# HISTORIC PRESERVATION COMMISSION

Proposal: Install HVAC system

Re: NYSHCR  
NYMS HVAC System for 201 Main St./Batavia  
201 E Main St, Batavia, Genesee County  
21PR04801

PROJECT TITLE  
**GO ART!**  
 201 EAST MAIN STREET  
 BATAVIA, NY 14020

DRAWING NUMBER  
**M-101**

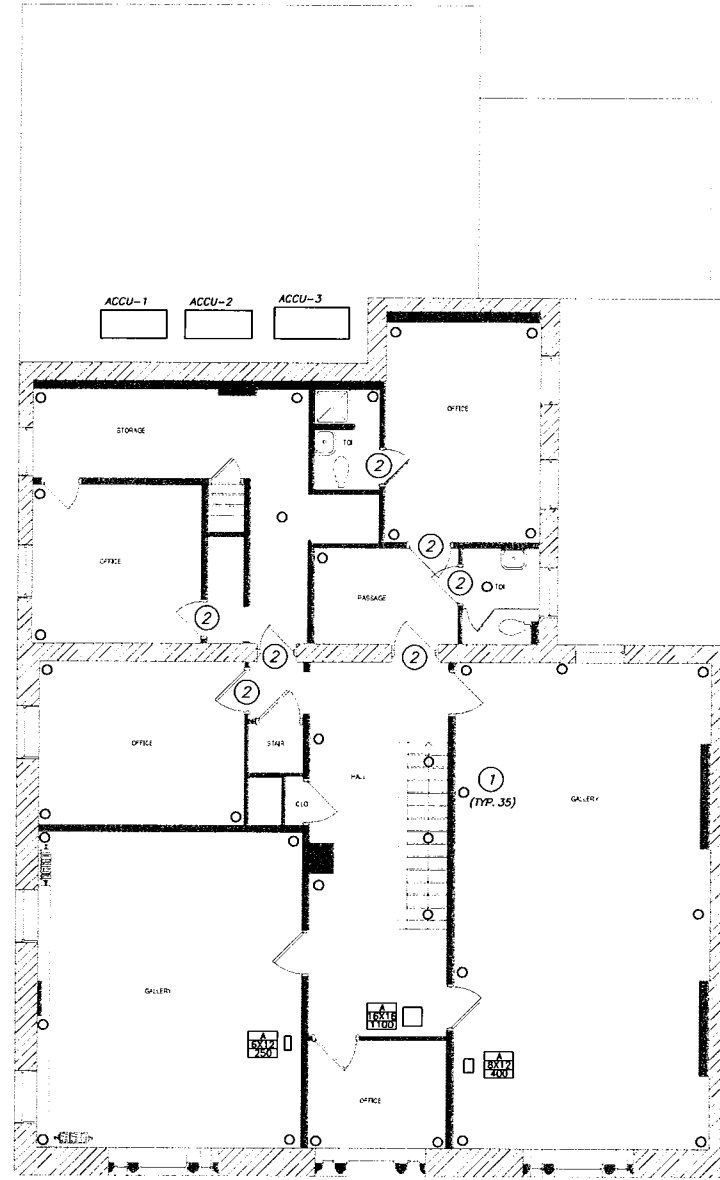
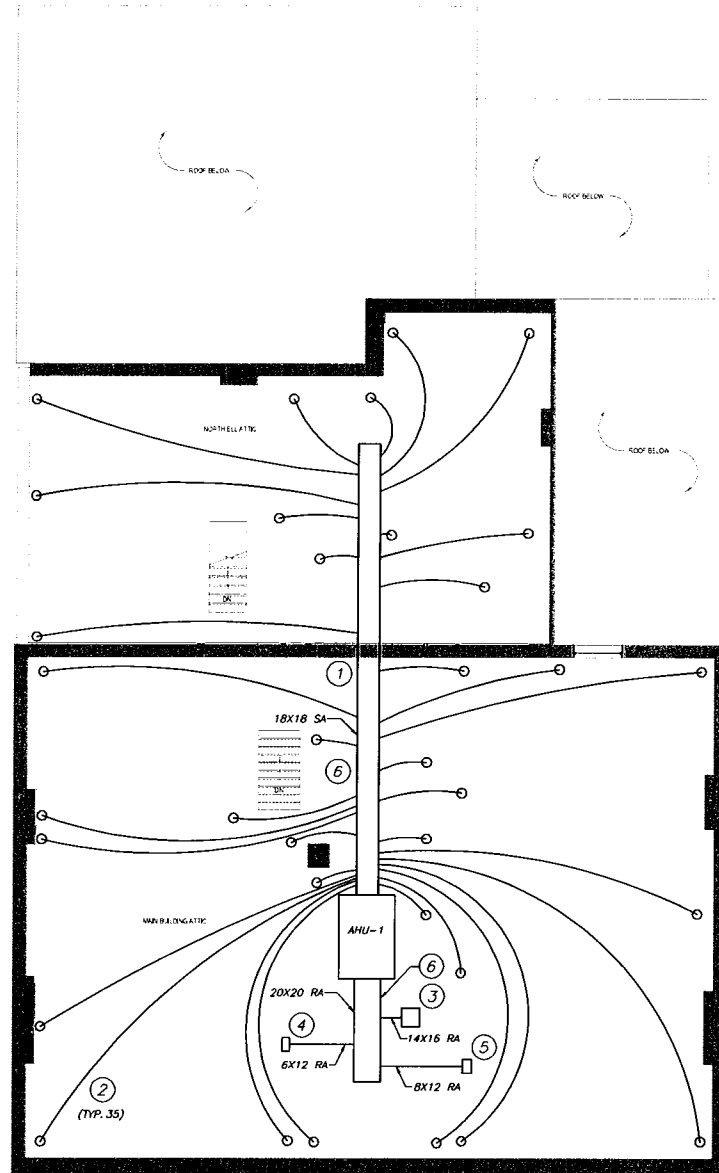
- Proposed HVAC penetrations should not impact any existing historic features or fabric and should be minimally visual. In order to understand the impact the proposed project may have on this historic resource, which retains a high degree of integrity, please provide more clarification on the following concerns:

- Will the nozzles be recessed or will they project into the space? What will be the size of the proposed ceiling penetrations? Will any architectural trim be impacted by the proposed ceiling penetrations? Is there any way to reduce the number of penetrations to decrease the amount of physical and visual change occurring in these historic spaces?

- We note that the proposal to shorten the historic doors in order to facilitate air flow is not an appropriate treatment. We recommend consideration of another method that allows for air flow without impacting any historic features or fabric.

We have reviewed the submission received on August 23 and August 31, including the email conversation dated August 4, 2021 and the Unico System Nozzle cut sheet. Based on that review, it is the SHPO's opinion that the project, as described, will have No Adverse Effect on historic resources.
